# MONA OFFSHORE WIND PROJECT

## Geomorphology Clarification Note

Document Reference: S\_D4\_7

Document Number: MOCNS-J3303-RPS-10313

Figure 1.1: Geomorphology survey locations

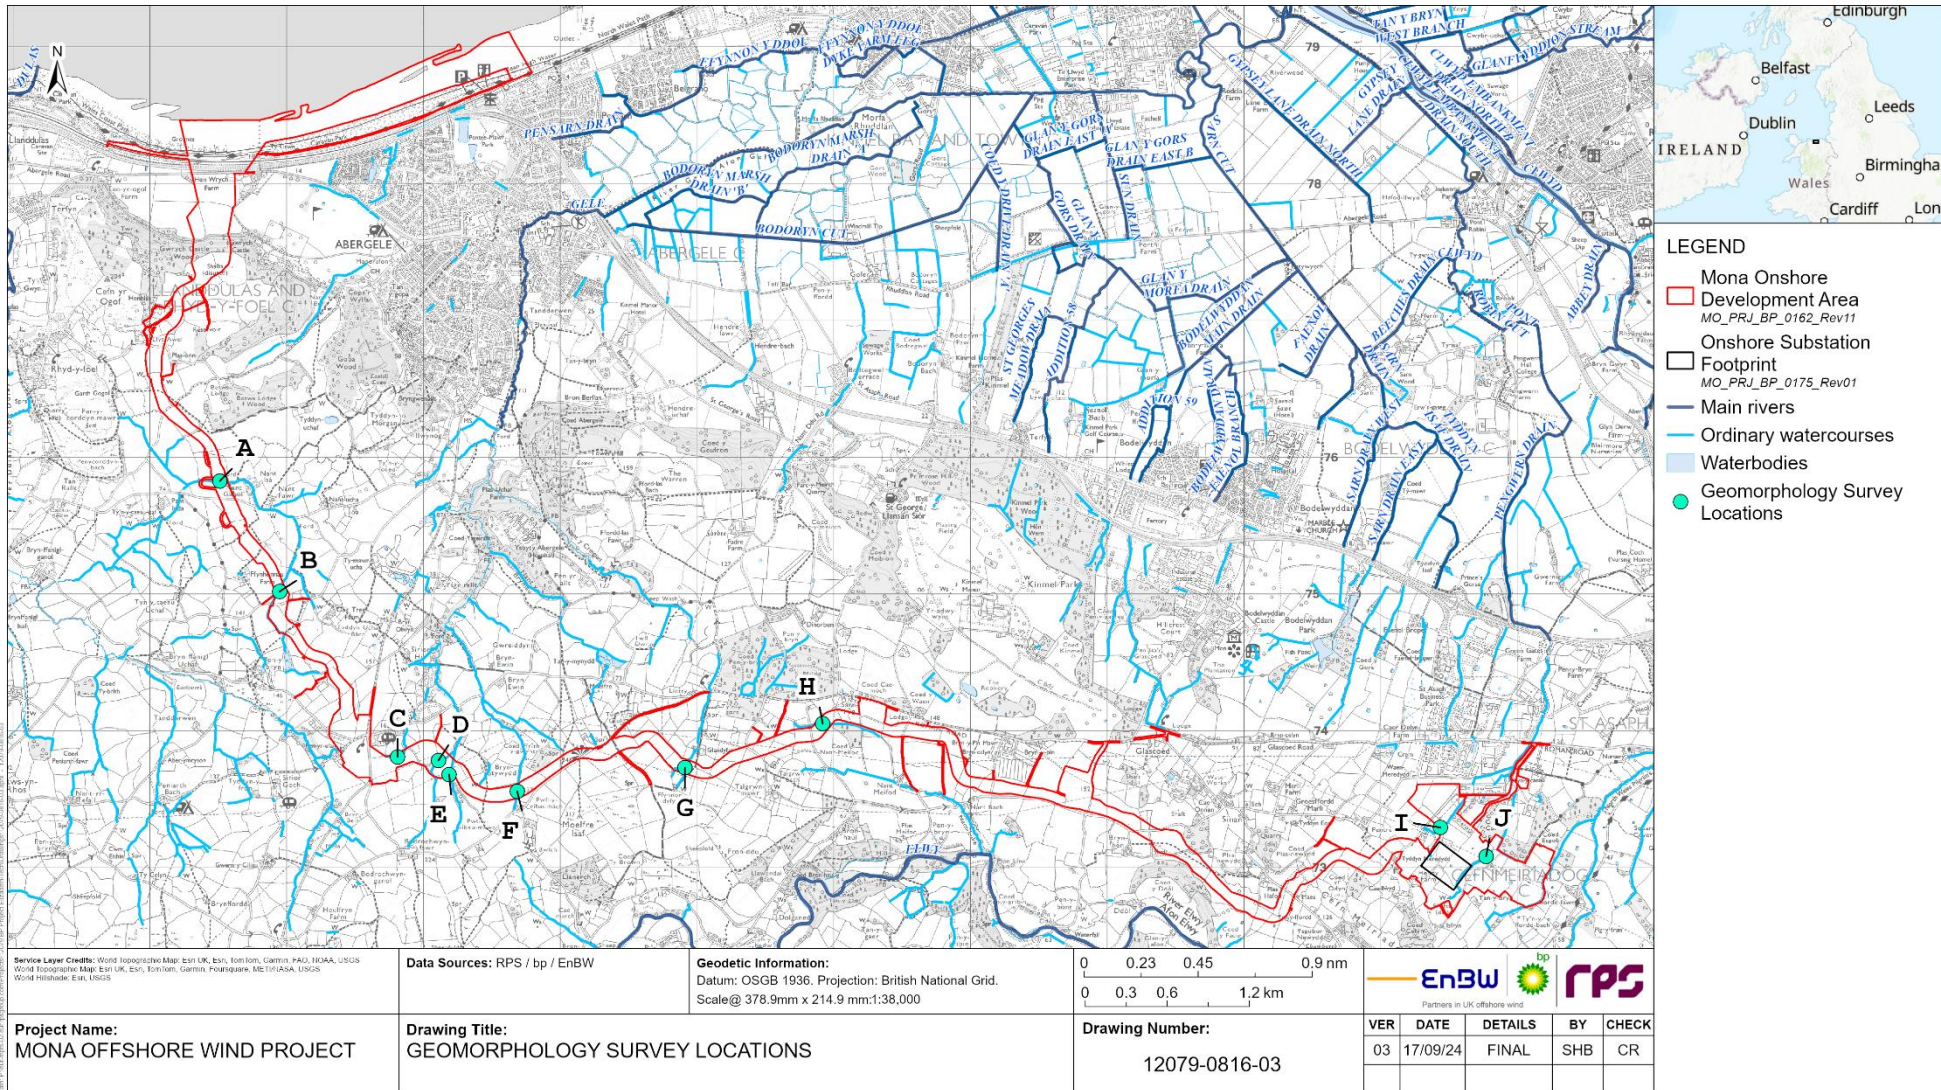
1.1.1.1 This document has been prepared in response to comments raised by Natural Resources Wales (NRW) in point 3.2.7 Fluvial geomorphology elements of the Water Framework Directive (WFD) of their Relevant Representation (RR-011), which states that:

*With the exception of being mentioned in the WFD assessment [APP-120] and partial related reference to impacts on habitats in the Onshore Ecology chapter [APP-066] section, the ES fails to specifically address fluvial geomorphology (the physical form and natural processes of rivers). Unlike other similar subjects (e.g. hydrology, flood risk, ecology, fisheries etc) there is no baseline fluvial geomorphology data (e.g. River Habitat Survey, MoRPh, Fluvial Audit), no impacts identified, no consideration of sensitivity of receptors, no significance of effect or cumulative impact of any of the proposed works with regard to fluvial geomorphology (e.g. open cut or trenchless crossings of watercourses, haul road bridges etc.). As stated in our previous response to the PEIR dated (1 June 2023 AOS-21167-0026) “More details of the geomorphological impacts associated with the proposals should be provided and suitable expertise sought.” This position remains valid.*

1.1.1.2 Conwy County Borough Council (CCBC) and Denbighshire County Council (DCC) also made the following comment regarding geomorphology characterisation in their Local Impact Report (REP1-048):

*Evidence to support statements such as in paragraph 2.7.2.3 [in APP-063] “For crossings of smaller watercourses (that are frequently dry) and drainage channels, open cut trenched techniques may be used” is important to ensure that the assessment has adequately considered potential effects relating to the watercourse crossings. The Councils request further baseline data provided in relation to fluvial geomorphology.*

1.2.1.1 The construction of the Mona Onshore Cable Corridor will cross ten Ordinary Watercourses (as shown on Figure 1.1). Information on these watercourses was gathered during onshore ecology surveys undertaken as part of the environmental impact assessment process.

1.2.3.1 The locations of the watercourses that will be crossed by the Onshore Cable Corridor and described in the geomorphology clarification note are shown on Figure 1.1 and listed in the table below:
